# Access Compliance Report

## Public Rights-of-Way

### (Curb Ramps)

Intersection ID: 10014519	Main Street: UNIVERSITY_POINTE_BV	Cross Street: N/A	Location: SE
ADA ID: 2BC20EBE68FF	Ramp Type: PerpDiag	Initial Pass/Fail: Fail	Overall Compliance: No
			Severity Score: 33.75

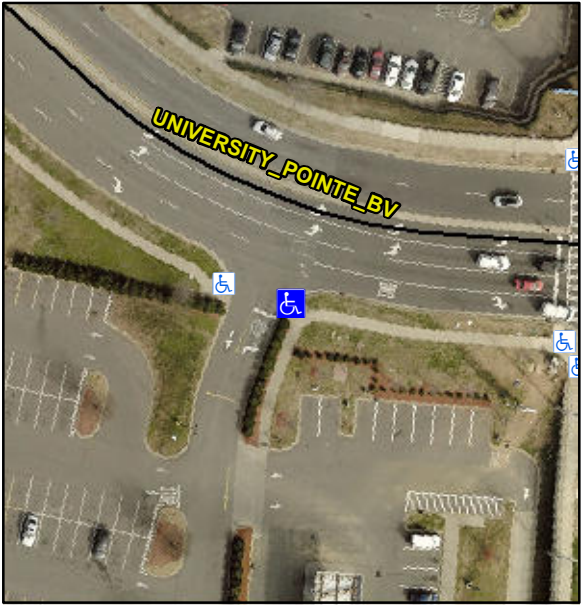
Codes/Mitigation Info/Possible Solution			Field Measurements/Component Compliance		
	Possible Solutions:		<b>Compliance</b>	<b>Description</b>	<b>Data</b>
	Remove & Replace Curb Ramp With Two New Directional Ramps or Equivalent.		N/A	Ramp Length (in)	88.0
			No	Ramp Width (in)	43.5
			N/A	Flare Type LT	N/A
			N/A	Flare Slope LT (%)	N/A
			N/A	Flare Traversable LT?	N/A
			N/A	Landing Length (in)	N/A
			N/A	Landing Width (in)	N/A
			N/A	Landing Slope (%)	N/A
			N/A	Landing X Slope (%)	N/A
			N/A	Landing Curb? (Y/N)	N/A
			N/A	Shared Landing?	N/A
			N/A	Gutter Ponding?	N/A
			N/A	Gutter Lip Ht (in)	N/A
			N/A	Painted X Walk1?	No
				X Walk 1 Direction	To N
			N/A	X Walk 1 Width (in)	N/A
				X Walk 1 Slope (%)	5.9
				X Walk 1 X Slope (%)	1.5
			N/A	Ramp inside XWalk1?	N/A
<p>Surveyor Notes:</p> <p>N/A</p> <p>PROW/ADA:</p> <p>R304.5.1, R304.5.3</p>			N/A	Flare Type RT	N/A
			N/A	Flare Slope RT (%)	N/A
			N/A	Flare Traversable RT?	N/A

N/A	DWS Provided?	N/A
			N/A	DWS Contrast?	N/A
			N/A	DWS Length (in)	N/A
			N/A	DWS Full Width?	N/A
			N/A	DWS Offset (in)	N/A
			N/A	Gutter Slope (%)	N/A
			N/A	Gutter X Slope (%)	N/A
			N/A	Painted X Walk2?	No
				X Walk 2 Direction	To W
			N/A	X Walk 2 Width (in)	N/A
				X Walk 2 Slope (%)	3.8
				X Walk 2 X Slope (%)	6.0
			N/A	Ramp inside XWalk2?	N/A
			N/A	Clear Space?	N/A
			N/A	Clear Space to XWalk (in)	N/A
			N/A	Storm Grate/Utility Hazard?	N/A
				Storm Grate/Utility Type	
			N/A		N/A
			Yes	Surface Condition? (G/P)	Good
Total Cost:		\$ 3200.00
